ADDITIONAL DOCUMENTATION REFERRED TO IN APPELLANT’S FLOOD RISK EVIDENCE

Land at Rectory Farm (Noth), Yatton, North Somerset

Flood Risk Assessment

July 2024 EA response to Mr Miram's technical note

Figure 1. Coastal Flood Boundary Dataset confidence intervals for the Woodspring Bay 2020 model.

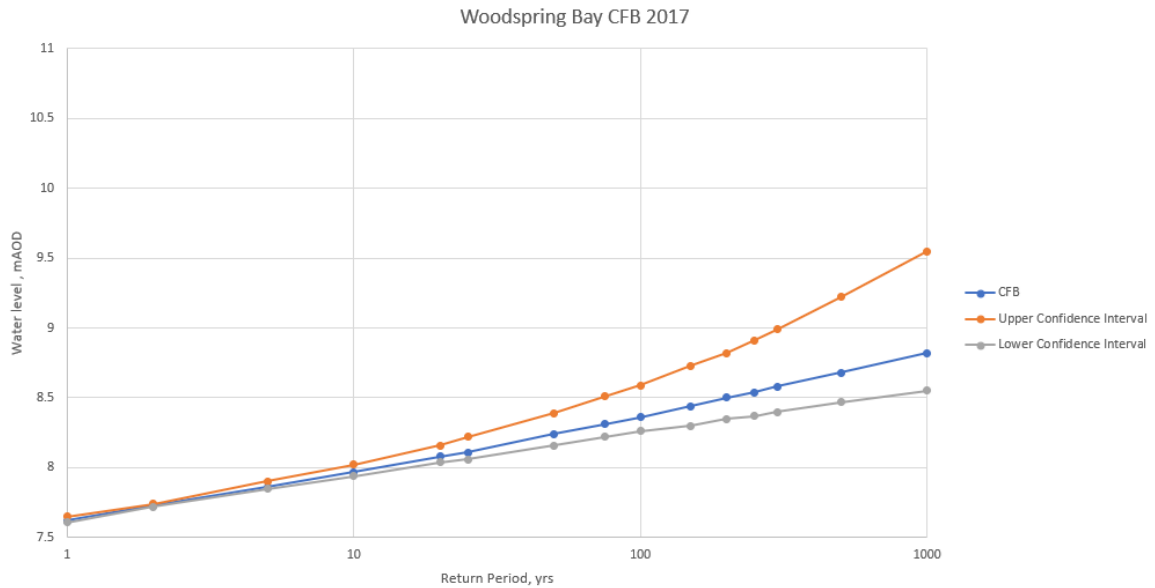
The Woodspring Bay model is a large tidal model. Part of the input data to the tidal model is the Coastal Flood Boundary Dataset (CFB), this dataset predicts peak tidal levels around the coastline for a range of annual exceedance probabilities (AEP), also known as return periods.

The CFB data itself has its own confidence intervals associated with the data – as shown below in Figure 2. For modelling, we apply the CFB levels (the blue line), but the data comes with upper and lower confidence limits. As the graph shows, uncertainty increases with increasing return periods. Up to about the 20-year event, confidence is very high, with <10cm difference between the range of possible levels, but by the larger events there are >50cm differences between the possible levels.

This uncertainty or tolerance relates to the absolute flood levels associated with each return period. When comparing pre and post-development scenarios, as both use the same input CFB derived data, the inherent uncertainty in the absolute levels has no bearing on the relative difference between the two scenarios. If changes to the hydraulic model (i.e. through representation of land raising) result in a change in water levels then this cannot be attributed to the uncertainty in input data as this would apply equally to both scenarios.
